DRAFT PILOT STUDY REPORT PERMEABLE REACTIVE TREATMENT (PeRT) WALL PILOT STUDY

Subject: Cape Canaveral Pilot Testing of PeRT Wall
AFCEE Contract No. 41624-94-D-8048
Draft Final Pilot Study Report, Version 2
Delivery Order No. 10
Rust Project No. 29515

**Response to EPA COMMENTS ON PILOT STUDY REPORT
PERMEABLE REACTIVE TREATMENT (PeRT) WALL PILOT STUDY
CAPE CANAVERAL AIR STATION
DRAFT FINAL, DATED JUNE 1999**

Response to Foremost Solutions Comments on Draft Final Pilot Study Report, Cape Canaveral Air Station PeRT Wall Pilot Study.

**FIGURE 4-1
GENERALIZED PORT WALL LAYOUT**

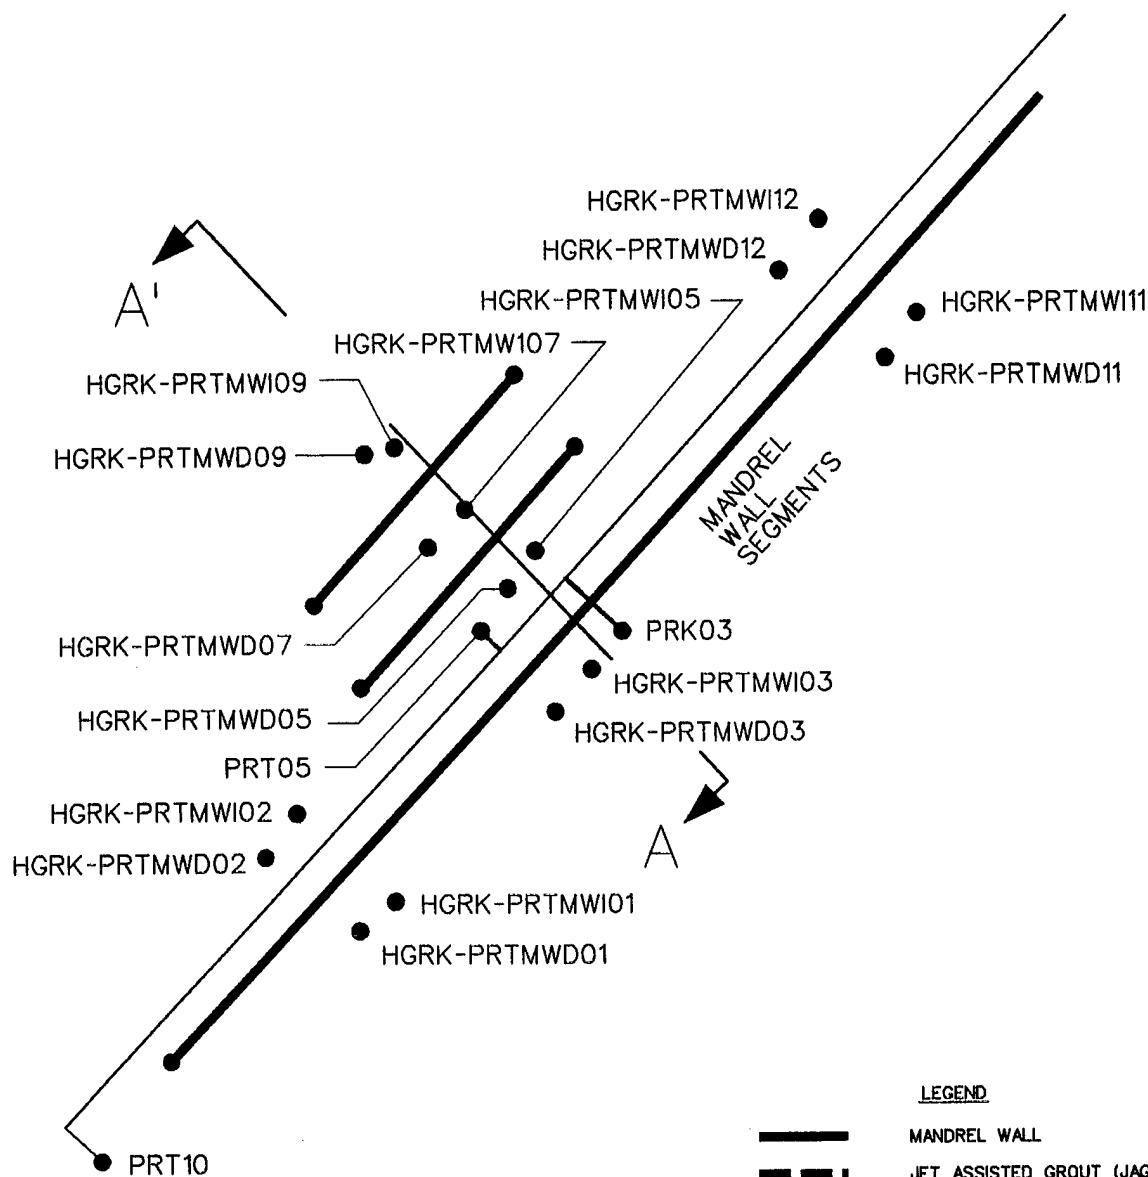
Comment Page 4.2

Dimensions on Plan View should be changed. The Mandrel was 48.0 feet and 11.2 feet. The JAG was 48.3 feet and 8.3 feet.

Response See response to first comment regarding lengths.

FIGURE 4-18
DEEP AQUIFER ZONE
POTENTIOMETRIC MAP FOR 2/1998
CAPE CANAVERAL AIR STATION, FLORIDA
PROJECT NO. 29515
NY 38748/9748K21DGN

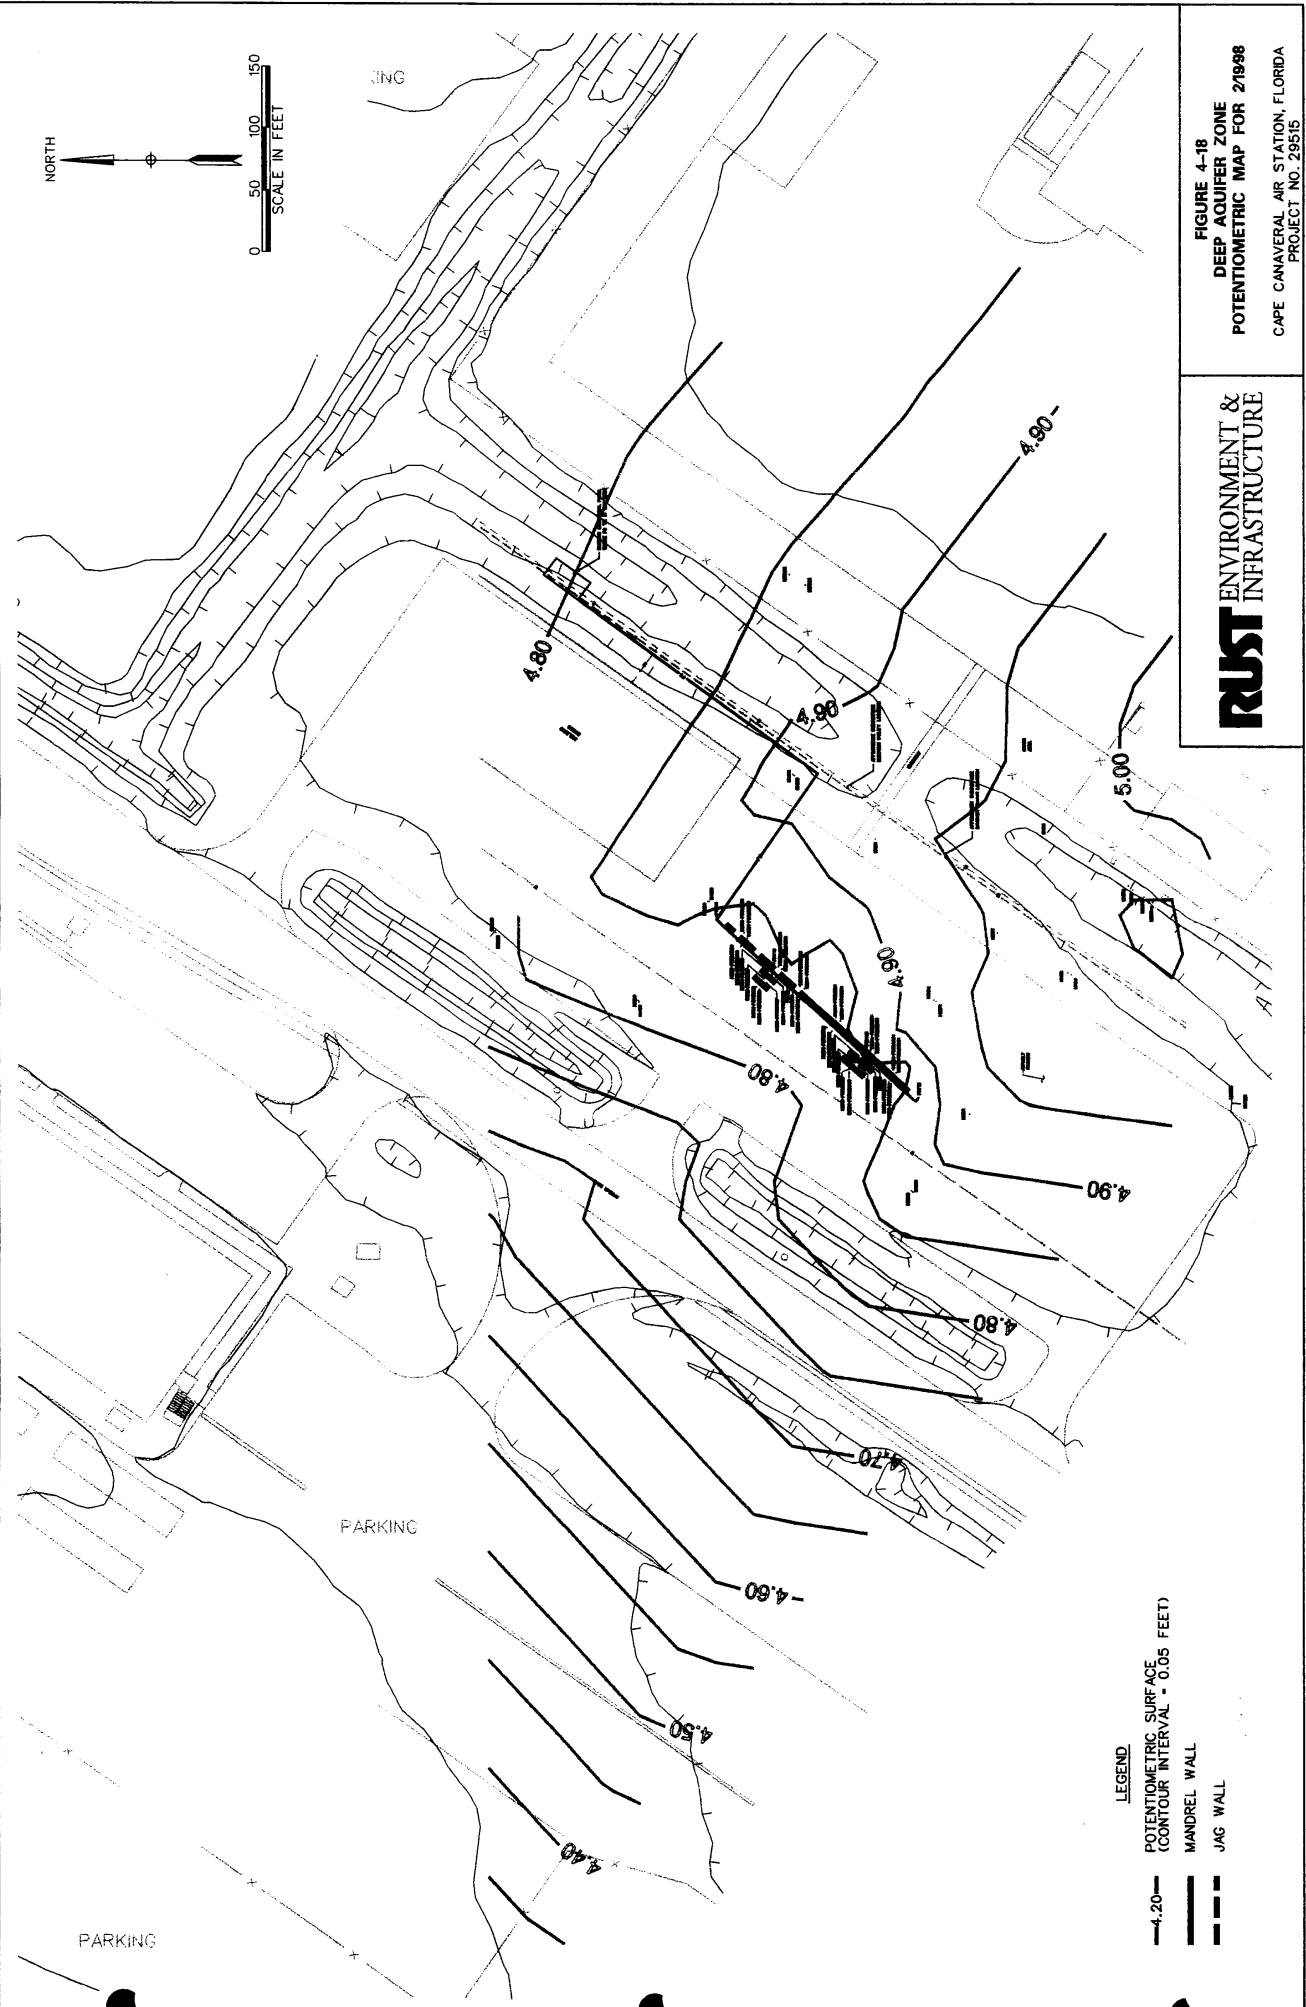
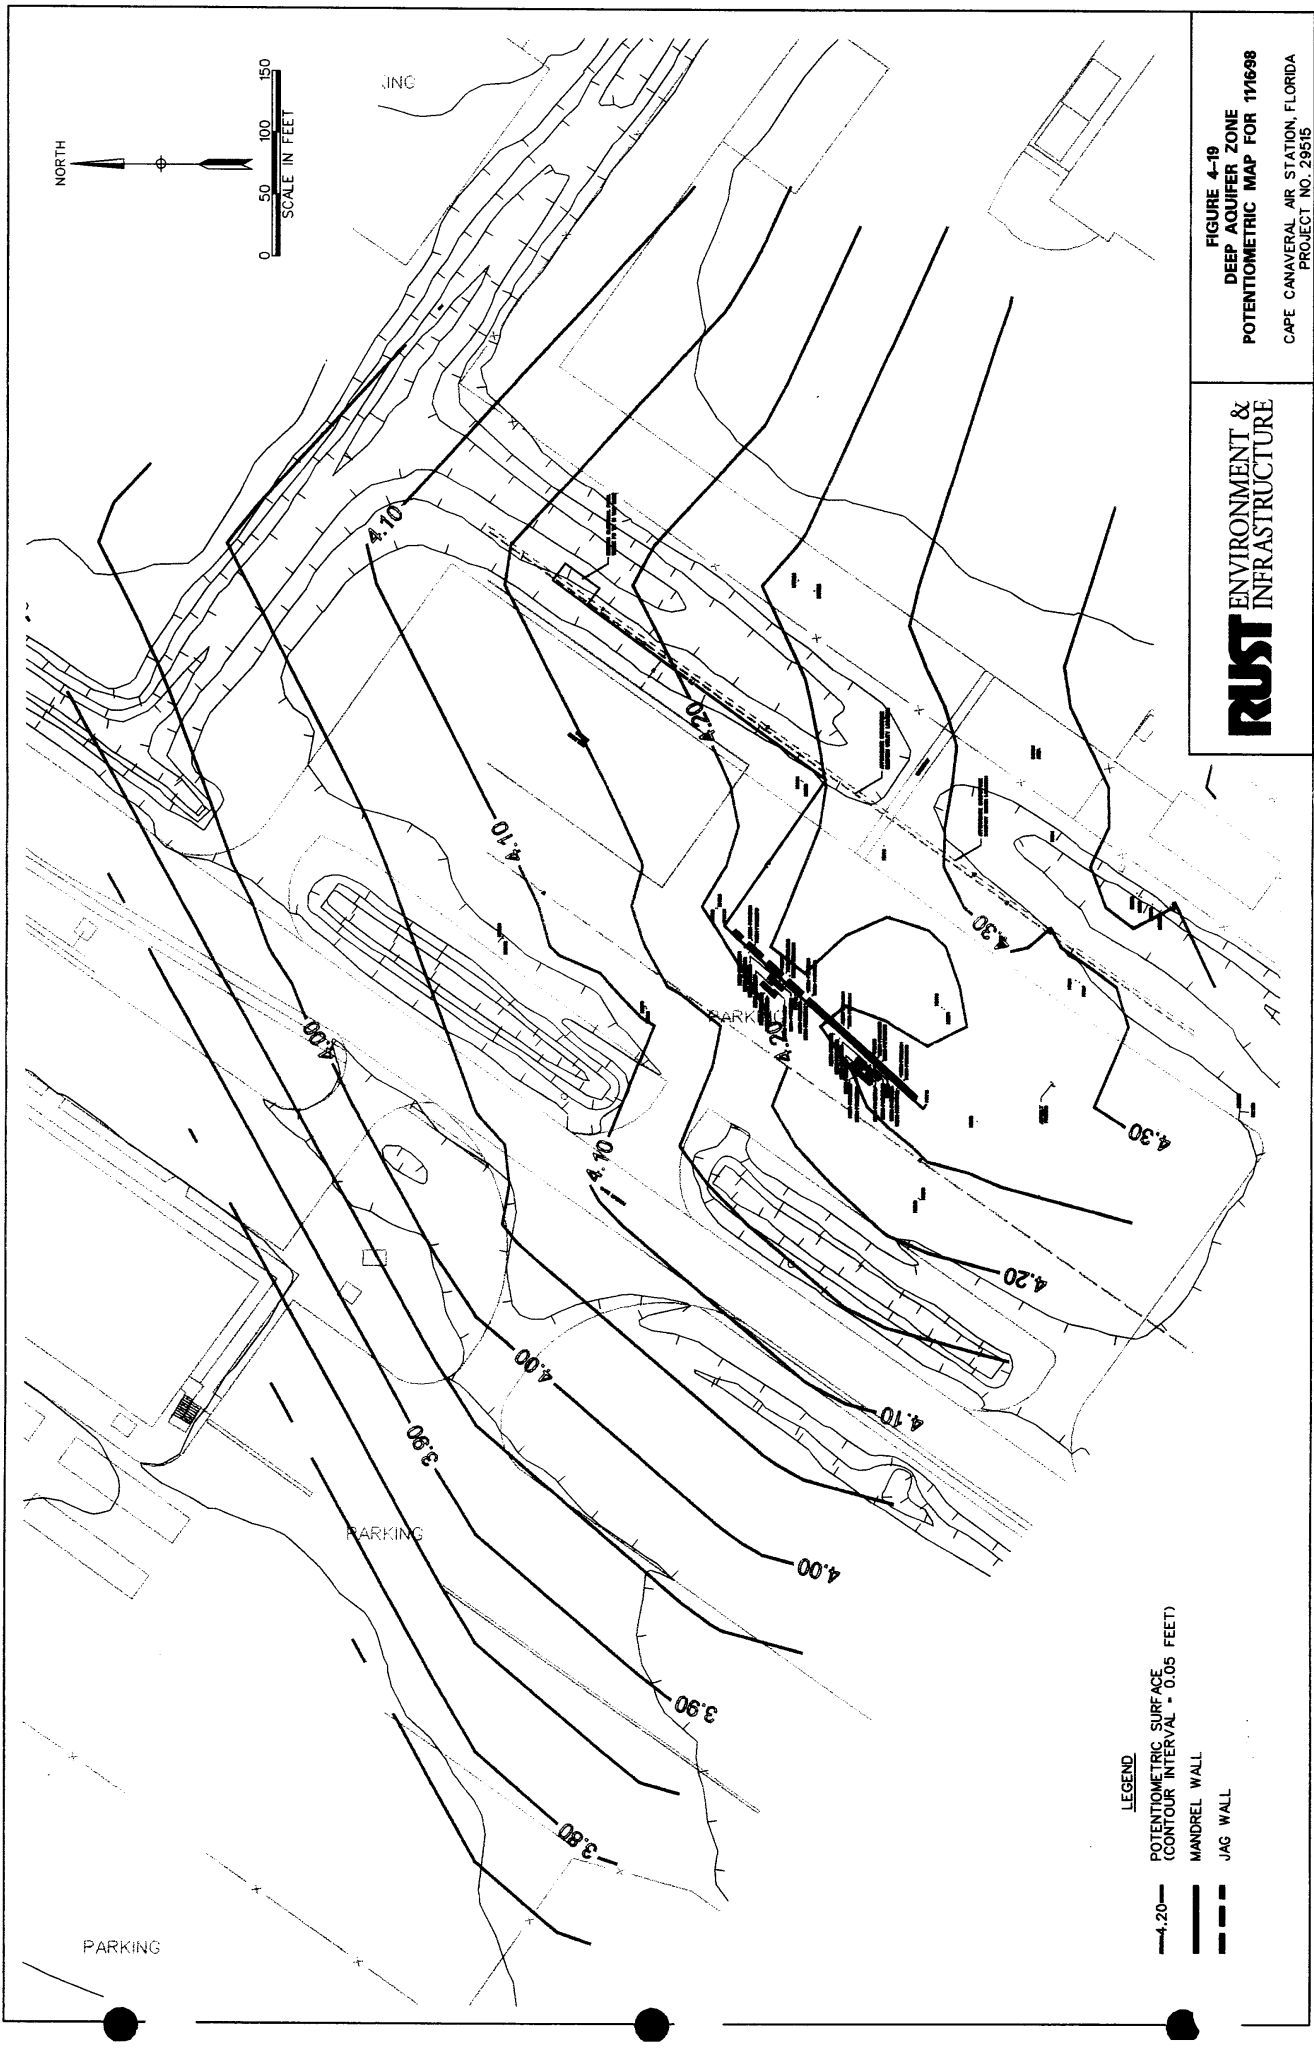
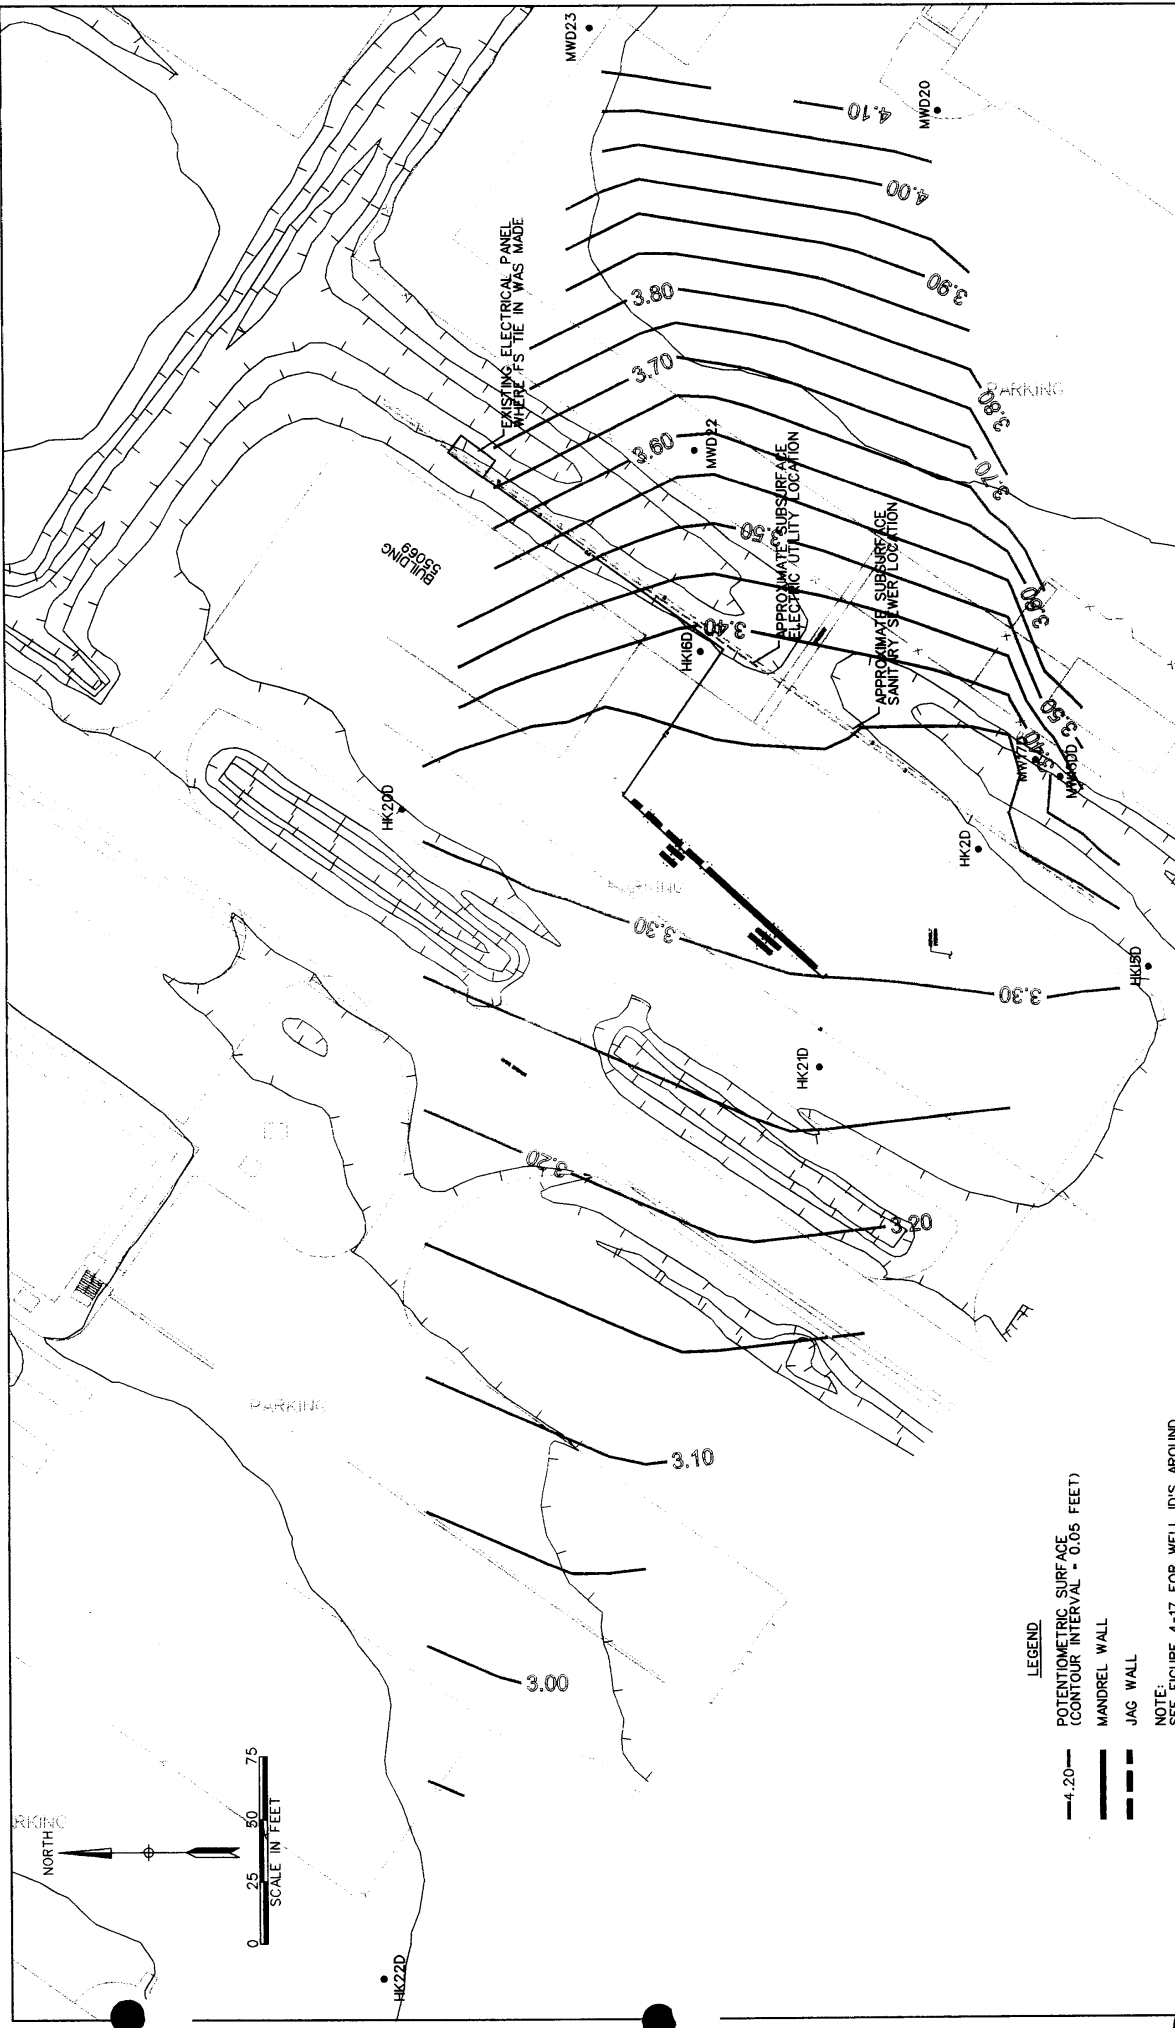
7		Table 4-34	COMMENT: C/E DCE should be C/T DCE. Please revise.
7			RESPONSE: Text will be modified as requested.
8		Figures 4-18, 4-19, and 4-20	COMMENT: The text labels associated with the monitoring wells and other objects is illegible. Please revise the figures to either increase the font size of the labels or reduce the scale of the map and adjust the labels accordingly.
8			RESPONSE: the three figures are being edited to show the wells used to construct the potentiometric surface, and refer to smaller scale maps for identification of the numerous wells around the PeRT wall. Reducing the scale of the map would render its purpose useless of showing the potentiometric surface for the whole area.
9	7-1	Section 7.1	COMMENT: Correct the reference to high OVA readings as per comment one.
9			RESPONSE: Text will be modified to list the maximum concentration as 450 ppm (as noted at HGRK-PRTMWD01).

FIGURE 5-1
Plot of Theoretical Concentration
Reduction over Time
Cape Canaveral Air Station, Florida

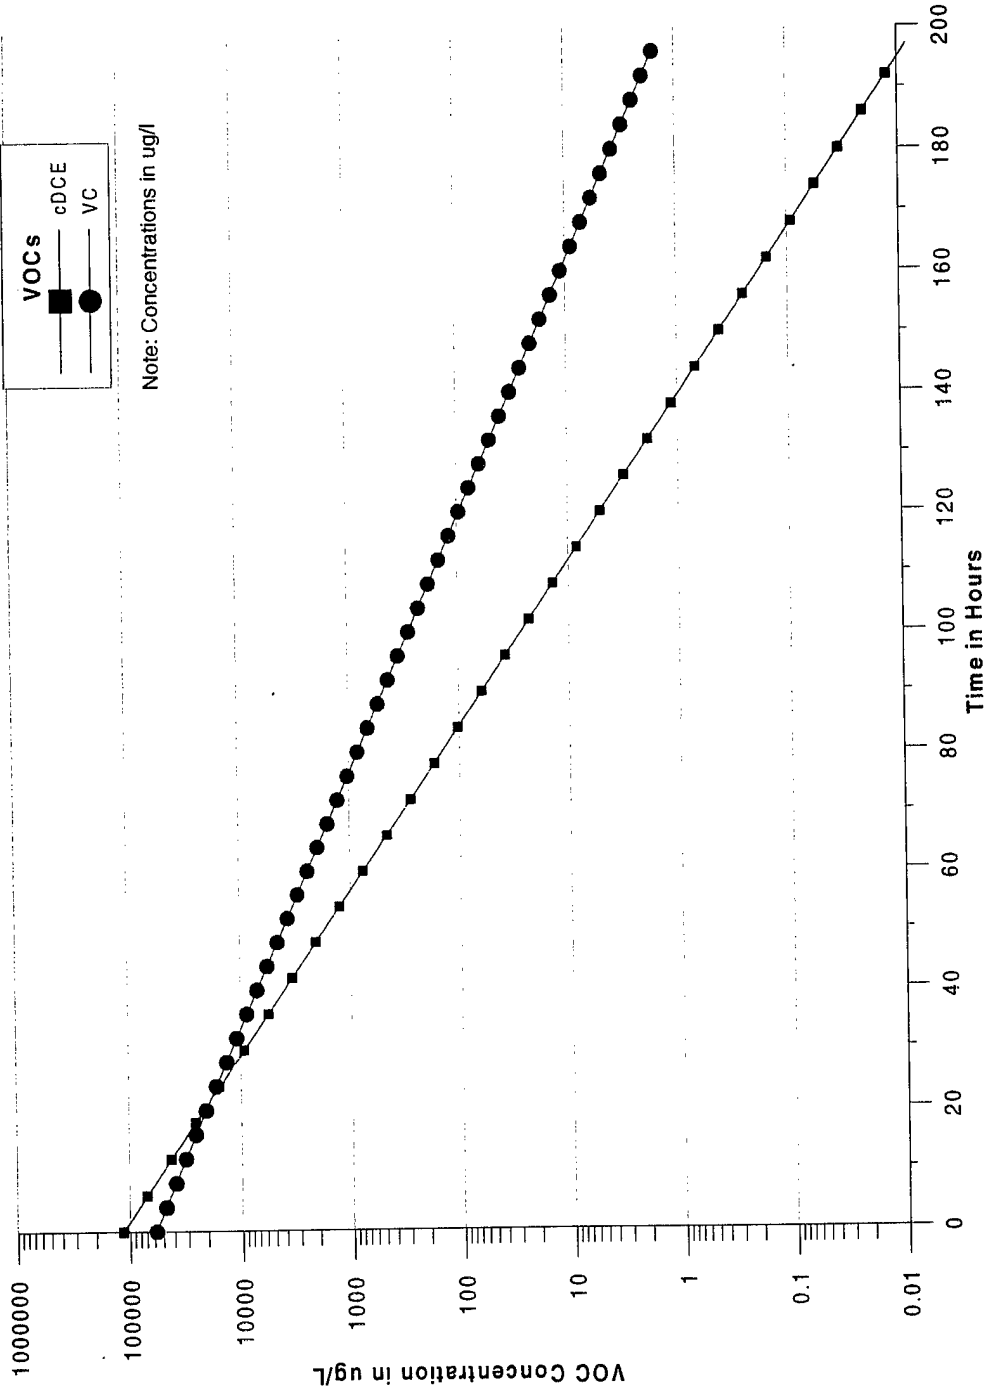
Comment Figure 5-1

Response: The figure will be revised to clarify.
